HISTORIC LANDMARK COMMISSION
STAFF REPORT

TRACY AVIARY BIRD HOLDING BUILDING
PLNHLC2012-00795
Liberty Park, 589 East 1300 South
December 5, 2012

SHEET NAME:
**VICINITY SITE PLAN
AND ENLARGED
SITE PLAN**

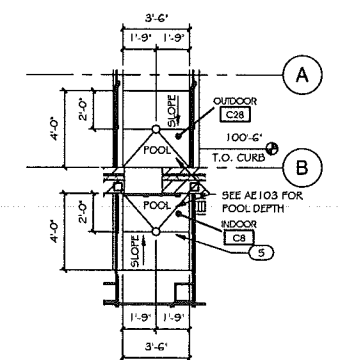
Analysis: At the December 1, 2011 meeting, the Commission stated that placing the building near the exterior sidewalk would be inappropriate, as it would create a blank wall that was not conducive to the overall enjoyment of the park. In response, the applicant moved the building approximately 12 feet away from the sidewalk, and is proposing decorative siding along the south elevation to provide interest in the building. This mixed with the proposed landscaping along the rear of the building will mitigate the impact of the wall as it relates to pedestrians along the sidewalk.

Finding: Staff finds that by moving the building away from the sidewalk, and providing landscaping, the applicant has restored the rhythm of spacing between the building and the sidewalk. This makes the building more compatible with the historic character of Liberty Park.
